Need for Replacement of High-Voltage Battery on Vehicles up to Model Year 2024: Observe Specified Procedure (02/25)

Model Line: **Taycan (Y1A / Y1B / Y1C)**

Concerns: **Replacing the high-voltage battery**

Component overview

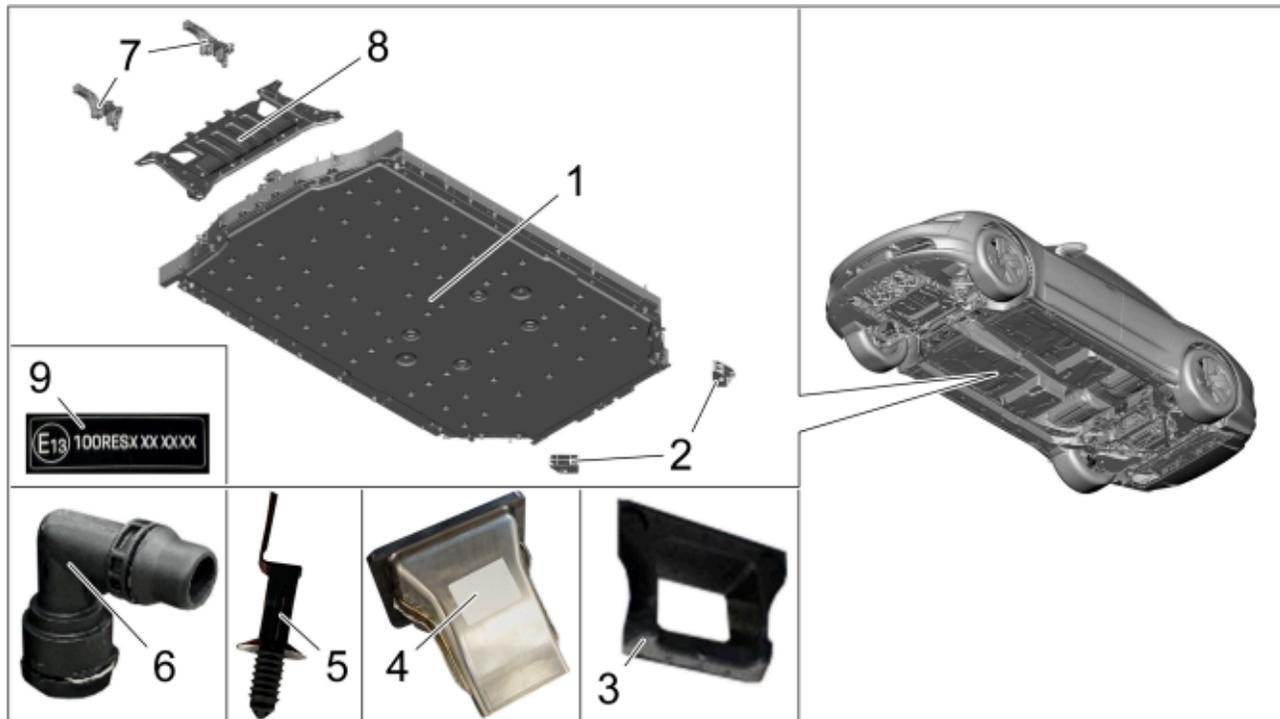
- 1 – High-voltage battery
- 2 – Mounting bracket (**change**)
- 3 – Acoustic seal
- 4 – Air duct (only for vehicles with country of delivery China)
- 5 – Cable tie with holder (only for vehicles with electrically active roll stabilization / M-no. 1P7), **2 piece(s) (replacement)**
- 6 – Coolant nozzle, **2 piece(s)**
- 7 – Anti-roll bar support on left and right, with rubber bearing (**replacement**)
- 8 – Front axle support rear section (**replacement**)
- 9 – Information sign / E-number label

Action: If the previous high-voltage battery needs to be replaced, replace it with a high-voltage battery from model year 2025 onwards.

Serial number (example)

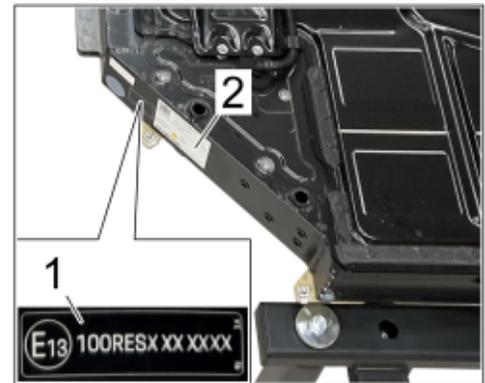
- 2 Photograph the type plate of the previously installed and new high-voltage battery and note down the serial numbers.

Affix E-number label

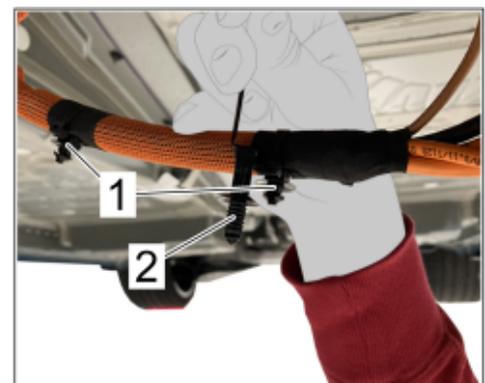
- 3 Affix E-number label ⇒ Affix E-number label -1- next to type plate ⇒ Affix E-number label -2- to new high-voltage battery.

Change mounting bracket

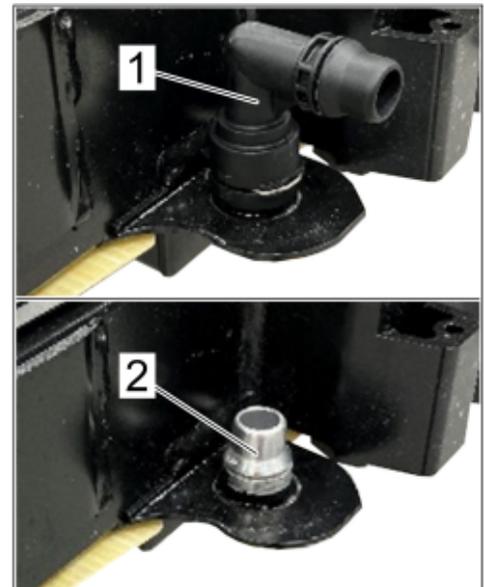
- 5 Change both mounting brackets ⇒ *Change mounting bracket -1-* of the removed high-voltage battery to the new high-voltage battery, while screwing in screws to the system by hand.

The screws of the mounting brackets are only tightened to the high-voltage battery when installed.

Replace anti-roll bar fastening

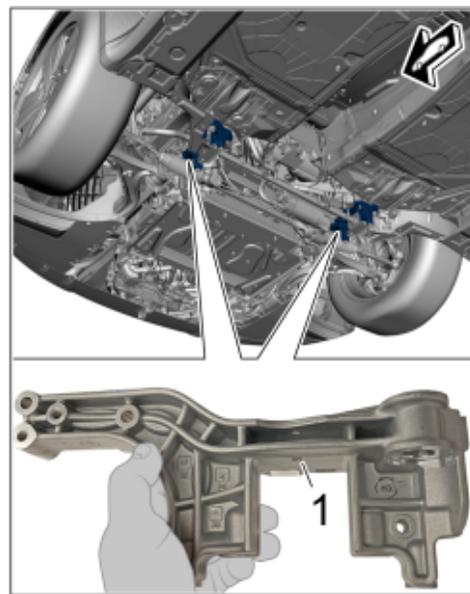
- 7 Replace anti-roll bar fastenings ⇒ *Replace anti-roll bar fastening -1-* with fastenings with model year 2025 component status, replacing rubber bearings.
